RE: Catch Basin Below Slurry Pipeline for Abatement of NOV #N84-2-13-1

RE: Review Based on Plans Submitted July 21, 1984 and a Site Visit July 18, 1984 Regarding NOV N84-2-13-1, Wellington Preparation Plant, ACT/007/012, #3 and #7, Carbon County, Utah

# EXHIBIT B

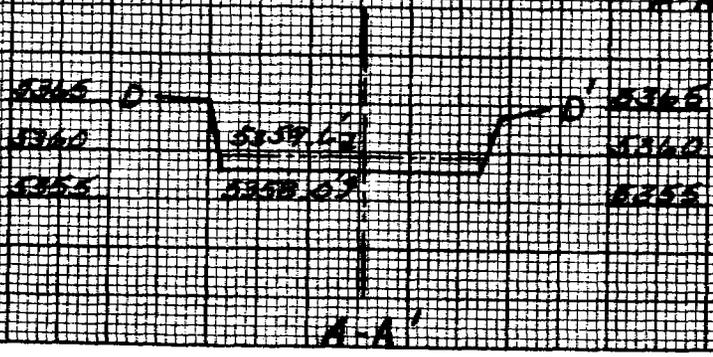
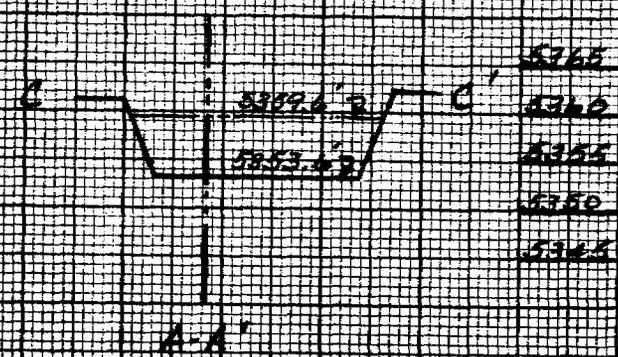
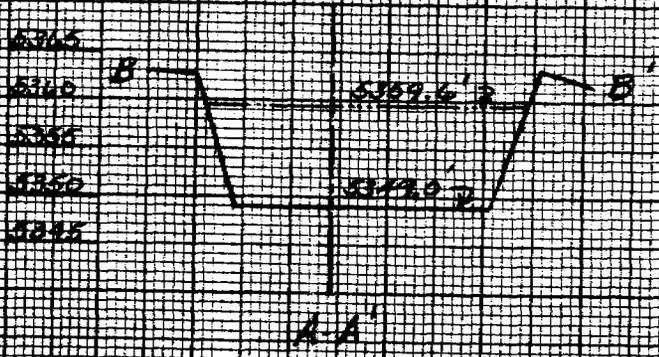
EXHIBIT B: This is a new exhibit showing basin cross sections which were surveyed on August 1, 1984. The capacity based on these sections is 0.57 AF (25,000 cu. ft.)

# EXHIBIT A

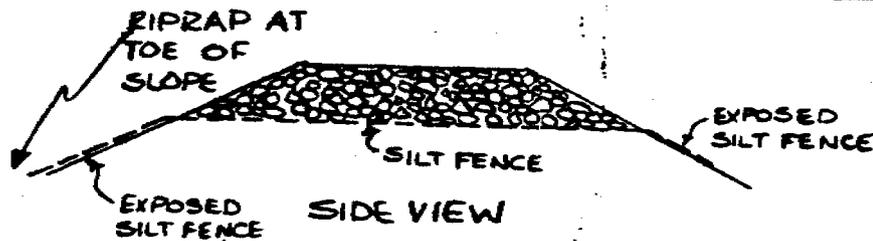
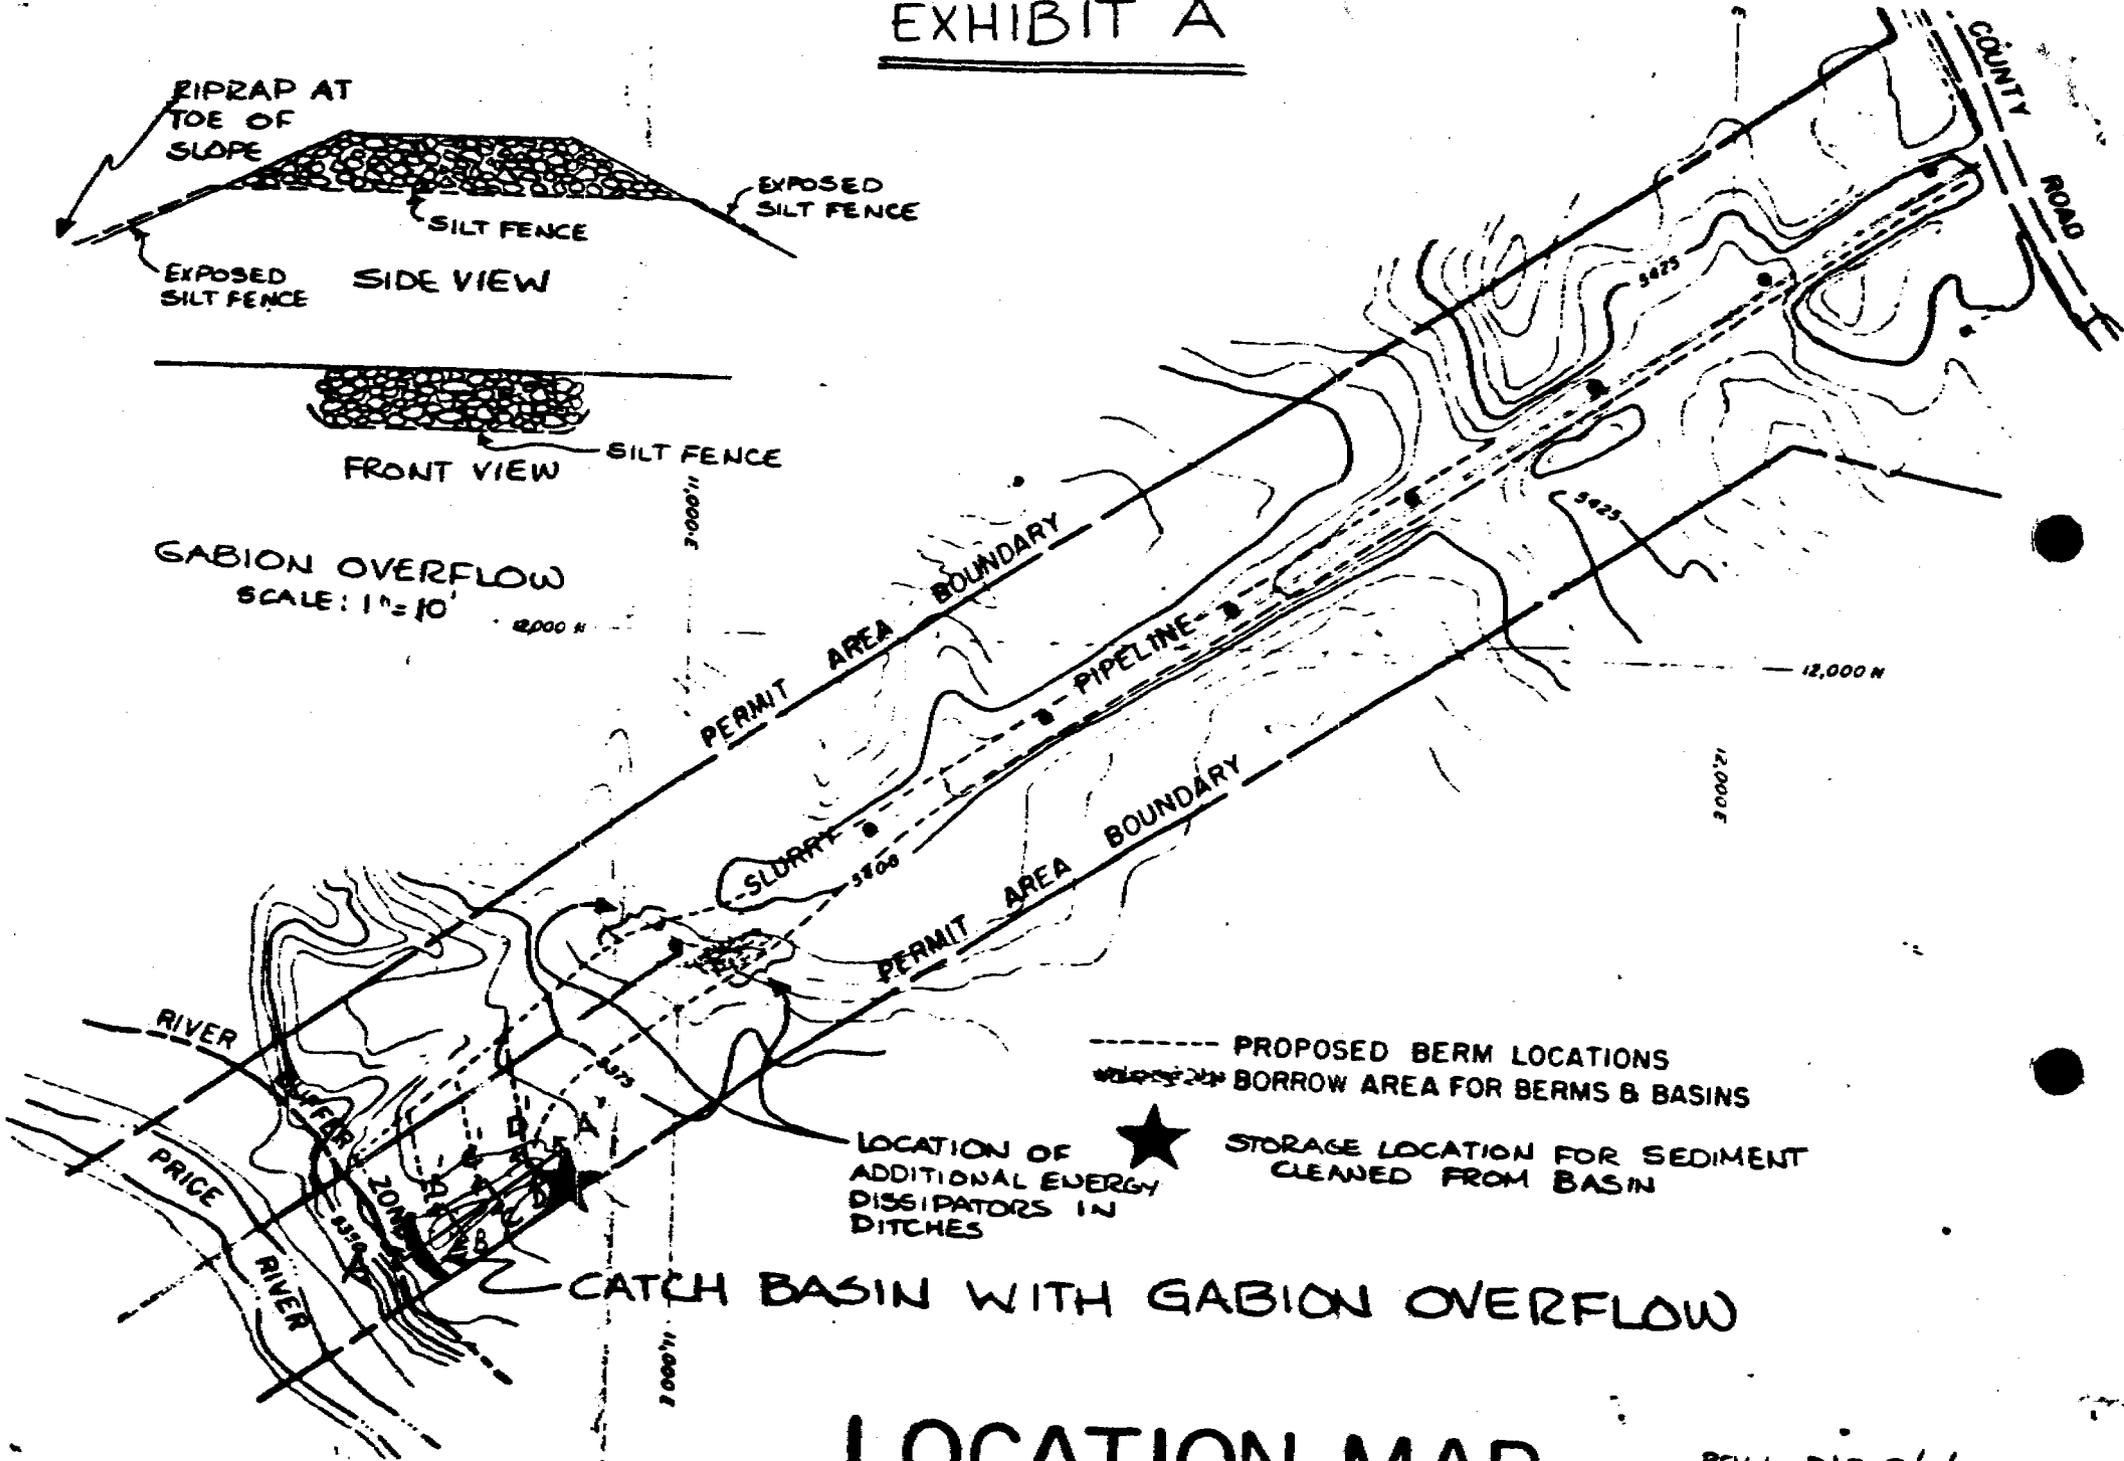
EXHIBIT A: This exhibit has been revised to locate the cross sections referenced on Exhibit B. Also, note the scale change on the gabion detail. The 1" = 5' scale shown on the June 28, 1984 submittal was in error.

REV. 1 - BAF. 8/2/84  
X-SECS; SCALE
